UNITED STATES PATENT AND TRADEMARK OFFICE

APPLICATION NO.	FILING DATE	FIRST NAMED INVENTOR	ATTORNEY DOCKET NO.	CONFIRMATION NO.
10/621,904	07/17/2003	Larry G. Willemsen	KSR-11302/08	. 2130
25006	7590 09/20/2005		EXAMINER .	
GIFFORD, KRASS, GROH, SPRINKLE & CITKOWSKI, P.C			LUONG, VINH	
PO BOX 702			ARTIBUT	DA DED MIMBER
TROY, MI 48007-7021			ART UNIT	PAPER NUMBER
			3682	
			DATE MAIL ED: 09/20/2005

•		<u>.</u> 1			
•		Application No.	Applicant(s)		
		10/621,904	WILLEMSEN ET AL.		
	Office Action Summary	Examiner	Art Unit		
		Vinh T. Luong	3682		
Period for	- The MAILING DATE of this communication ap	pears on the cover sheet with the c	orrespondence address		
A SHO WHICI - Extens after S - If NO I - Failure Any re	DRTENED STATUTORY PERIOD FOR REPL HEVER IS LONGER, FROM THE MAILING D sions of time may be available under the provisions of 37 CFR 1.1 (6) MONTHS from the mailing date of this communication. period for reply is specified above, the maximum statutory period to reply within the set or extended period for reply will, by statute ply received by the Office later than three months after the mailing dipatent term adjustment. See 37 CFR 1.704(b).	NATE OF THIS COMMUNICATION 136(

ATTACHMENT

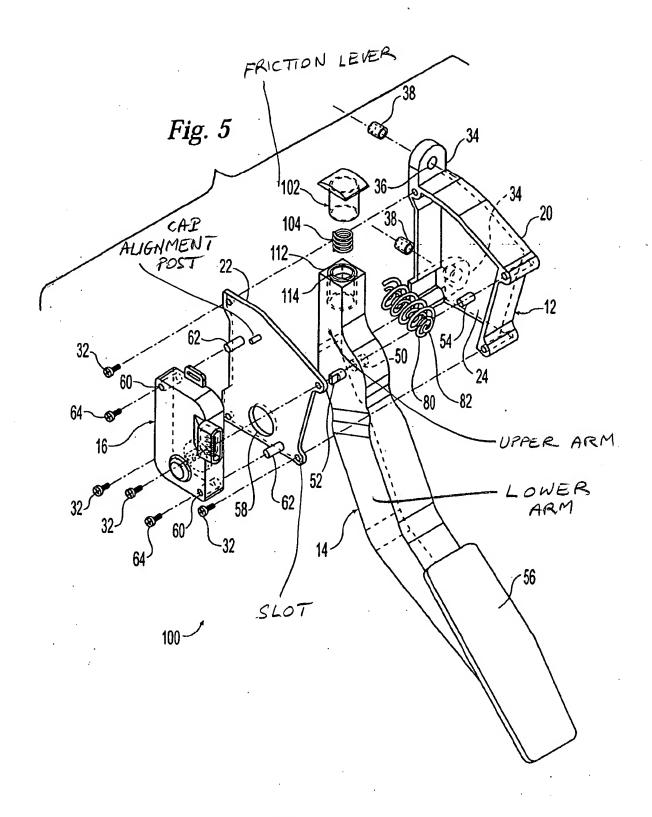
a pedal arm 14 having an upper arm (see Attachment) and a lower arm (Att.) and is rotatably supported at said pedal arm pivot point 52 that is between said upper pedal arm (Att.) and said lower pedal arm (Att.) by a mounting means 52 operatively connected to said housing 20;

Regarding claim 7, said pedal arm 14 includes a disk portion (Att.), and said lower pedal arm (Att.) extends from a lower edge (Att.) of said disk portion (Att.) and said upper pedal arm (Att.) extends from an upper edge (Att.) of said disk portion (Att.).

an alignment post (unnumbered in Fig. 5. See Att.) extending radially from a face portion of said cap 22, wherein said alignment post (Att.) aligns said cap 22 with said pedal arm pivot point 52;

Regarding claim 12, said cap 22 includes at least one slot (Fig. 5. See Att.) for securing the cap assembly 22 to said housing 20 in a predetermined position (by screws 32).

a pedal arm 14 rotatably supported at said pedal arm pivot point 52 by a mounting means 52 operatively connected to said housing 20, wherein said pedal arm 14 includes a disk portion (Fig. 6, Att.), a lower pedal arm (Att.) extending from a lower edge (Att.) of said disk portion (Att.) and an upper arm (Att.) extending from an upper edge (Att.) of said disk portion (Att.) and said pedal arm pivot point 52 is between said upper pedal arm (Att.) and said lower pedal arm (Att.);

a hysteresis generating means 18 pivotally mounted to said upper pedal arm (by the cavity 112 so as to pivot about the pivot axis 52 as seen in Fig. 6. See Att.), wherein said hysteresis generating means 18 is a friction lever 102 pivotally mounted (by the cavity 112) to an outer end (Fig. 6. See Att.) of said upper pedal arm (Att.) at a friction lever pivot point 52; and a spring 80, 82 positioned between said housing 20 and said hysteresis generating
